Agenda Item 14A

Communication from the City Plan and Zoning Commission advising that at their meeting held September 19, 2013, the following action was taken regarding a request from East Village Growth Partners, LLC (purchaser) represented by Tim Rypma (officer) for reconsideration of a Site Plan under design guidelines in "C-3B" Districts and for multiple-family dwellings on property located at 350 East Locust Street. The subject property is owned by the City of Des Moines.

East Village Growth Partners LLC -
Air Rights along the north side of East Locust St west of E 4th St 11-2013-1.15

DECK ENCROACHMENT DETAIL

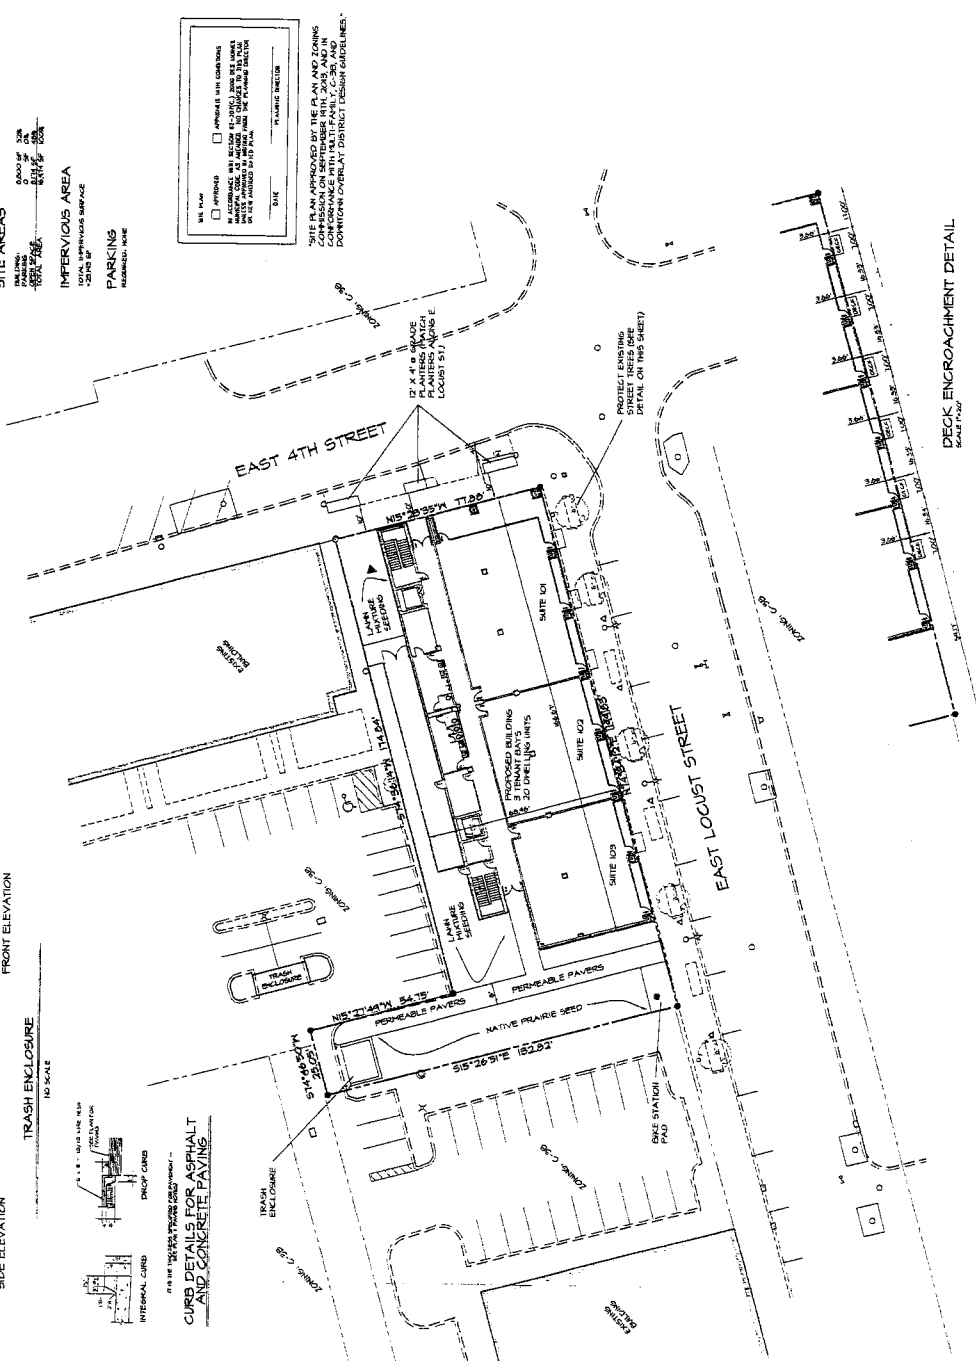
The proposed Site Plan revisions allow a balcony for each of the six (6) residential units on the 4th floor. This requires vacation of air rights for the north 4 feet of East Locust Street right-of-way adjoining the building. The proposed elevations indicate the balconies would be constructed of metal frames with glass in-fill. In order to minimize the chance of items falling from the balconies onto the public sidewalk below, the

balconies should have a rounded top railing and/or no ledge to set items on.

1. Any balcony constructed is shall generally be in accordance with the submitted building elevations and site sketch.
2. Any balcony constructed shall have a rounded top railing and/or no ledge.
